## **North Common — \$500,000 to \$550,000 estimate**

RE: North Common Rehabilitation and Modernization, Spring Street, S. Pleasant Street, Main Street, and Boltwood Avenue, Amherst, MA; MHC# RC. 52780

**PARC Grant Proposal**  
**Improvements & Modernization of the North Common**  
**Amherst, MA**

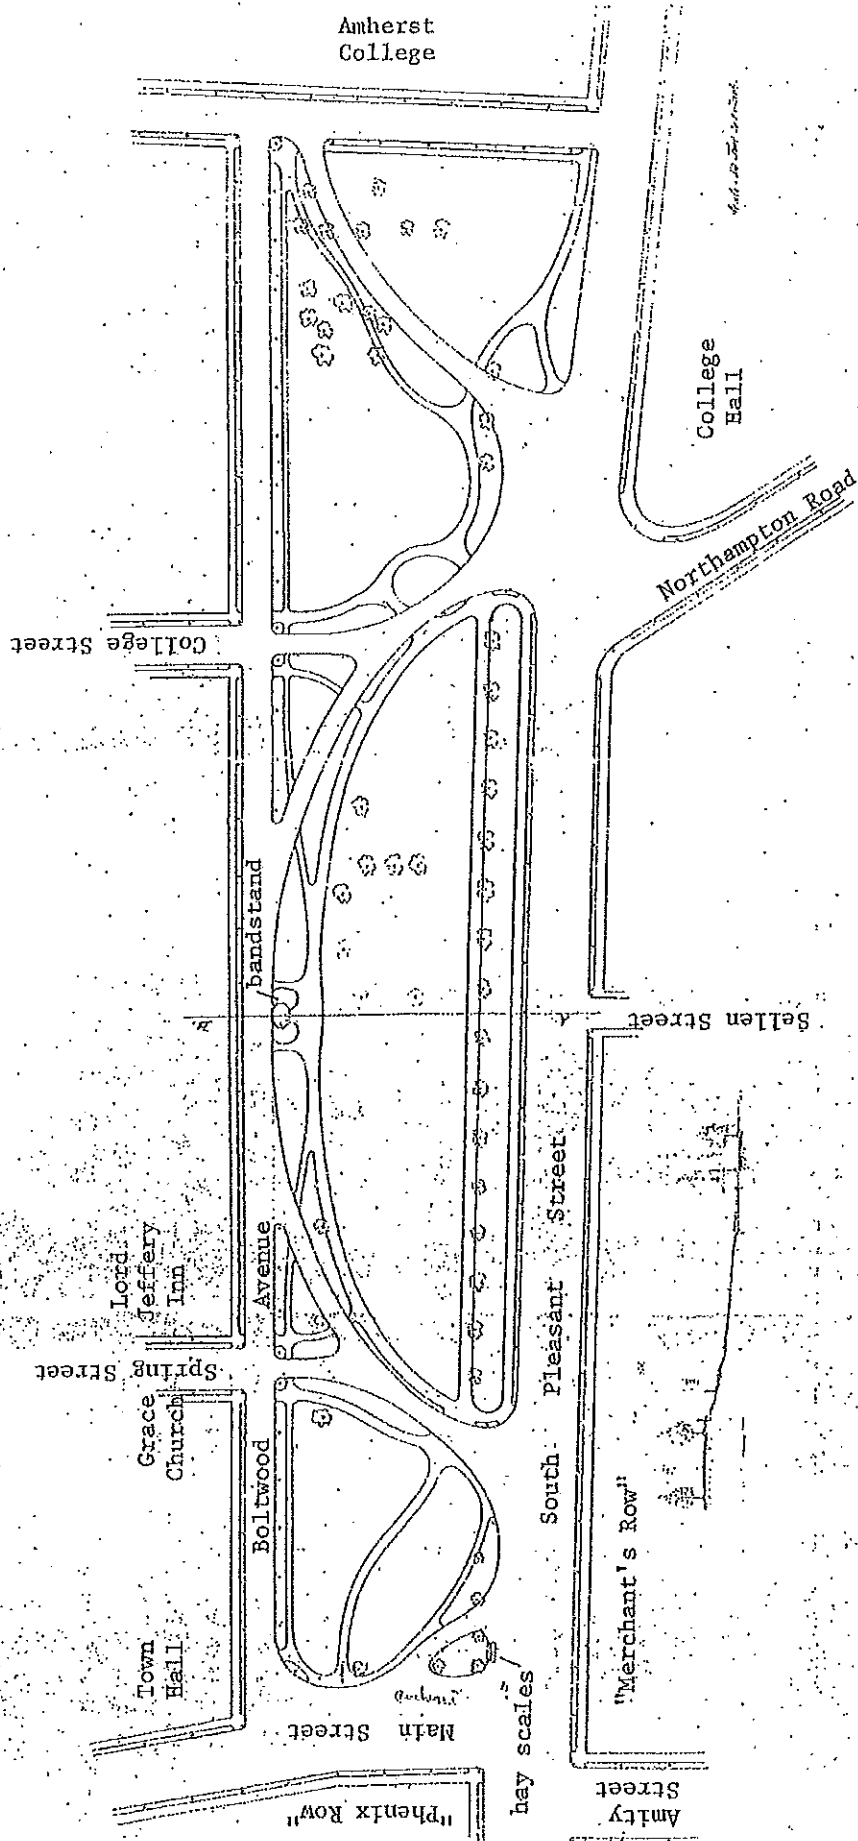
- **Is any tree preservation envisioned?**

- **As noted in the proposal, the North Common is particularly notable for its many trees, dating back to the work of the Amherst Ornamental Tree Association 150 years ago. What is the vision for tree cover in the conceptual design?**

- **How large is the current greenspace on the North Common? Will the new design include the same amount of greenspace or will more land be paved over for sidewalks, paths, plazas, etc.?**

Yes, many of the existing trees are incorporated into the design—only 2 of the 16 existing trees are indicated for removal on the concept plan. That being said, this section of the Town Common, including the tree plantings, has not been developed following a comprehensive design. It is expected that a new design will keep some of the existing trees and propose new trees as necessary. The Public Shade Tree Committee and Town’s Tree Warden have attended

The concept design retains all but 2 of the existing 16 trees and proposes planting 6-10 understory and canopy trees. The design provides shade for the sitting areas and along the pathways, and will add canopy in anticipation of the existing trees aging.

The concept design includes wider sidewalks and more interior pathways as well as more areas for sitting and gathering, in an effort to encourage residents and visitors to enjoy the space and to accommodate where people walk now, which is often not on the walkway. The design works with the existing topography to use paved areas to help fix the drainage and to better accommodate pedestrians with accessible pathways where people want to walk. The design may add more hardscape but the upshot is that the green space will be better maintained to help grass and plantings grow.
